The amendment revises the Technical Specifications to increase Maximum Average Planar Linear Heat Generation Rate (MAPLHGR) operating limits by allowing credit for core spray heat transfer.

PILGRIM NUCLEAR POWER STATION
AMENDMENT TO FACILITY OPERATING LICENSE

Amendment No. 59
License No. DPR-35

SAFETY EVALUATION BY THE OFFICE OF NUCLEAR REACTOR REGULATION

FIGURE 3.11-5
MAXIMUM AVERAGE PLANAR LINEAR HEAT GENERATION RATE
VERSUS
PLANAR AVERAGE EXPOSURE
FUEL TYPE P8DRB282

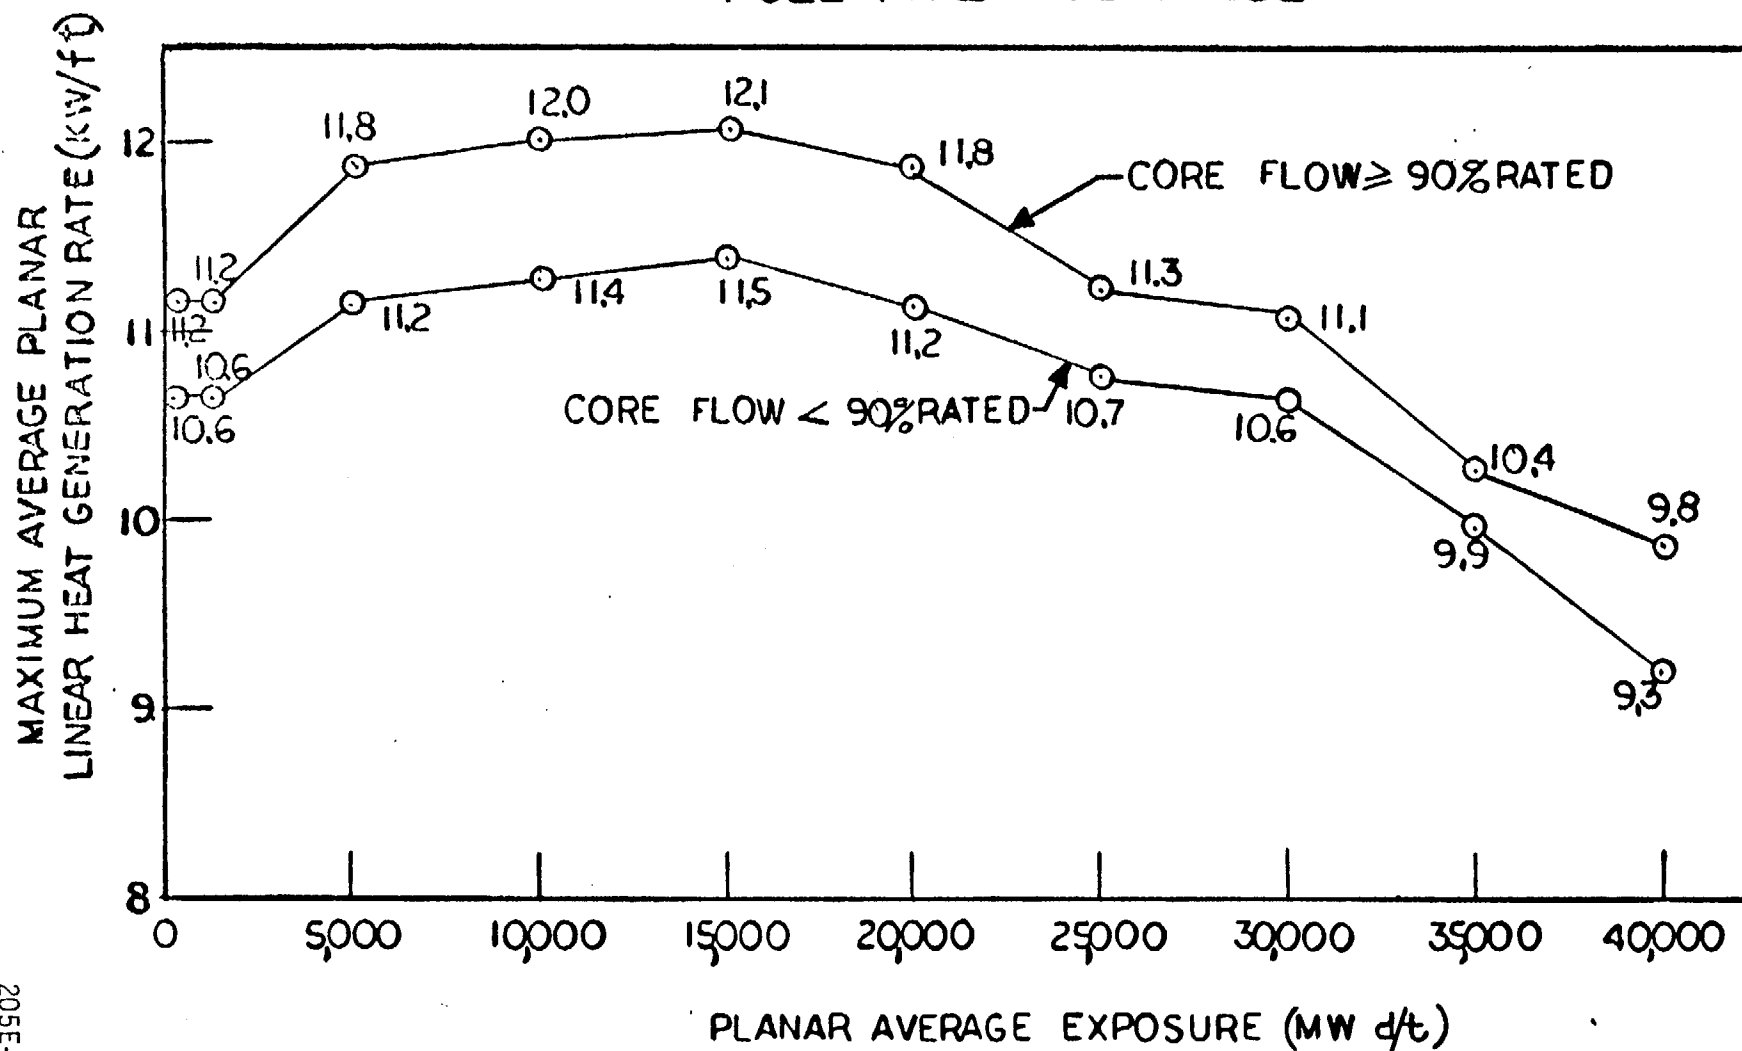
During power operation with both recirculation pumps operating, the APLHGR for each type of fuel as a function of average planar exposure shall not exceed the applicable limiting value shown in Figures 3.11-1 through 3.11-6. The top curves are applicable for core flow greater than or equal to 90% of rated core flow. When core flow is less than 90% of rated core flow, the lower curves shall be limiting. If at any time during operation it is determined by normal surveillance that the limiting value for APLHGR is being exceeded, action shall be initiated within 15 minutes to restore operation to within the prescribed limits. If the APLHGR is not returned to within the prescribed limits within two (2) hours, the reactor shall be brought to the Cold Shutdown condition within 36 hours. Surveillance and corresponding action shall continue until reactor operation is within the prescribed limits.

Based on our review, we conclude that the LOCA calculations submitted for Cycle 6 operation (assuming credit for core spray heat transfer) satisfy the criteria of 10 CFR 50.46 and are therefore acceptable. We have also reviewed the licensee's proposed changes to Technical Specifications involving the increased MAPLHGR operating limits and conclude that these changes are in accordance with these calculations. Consequently, we find them acceptable.
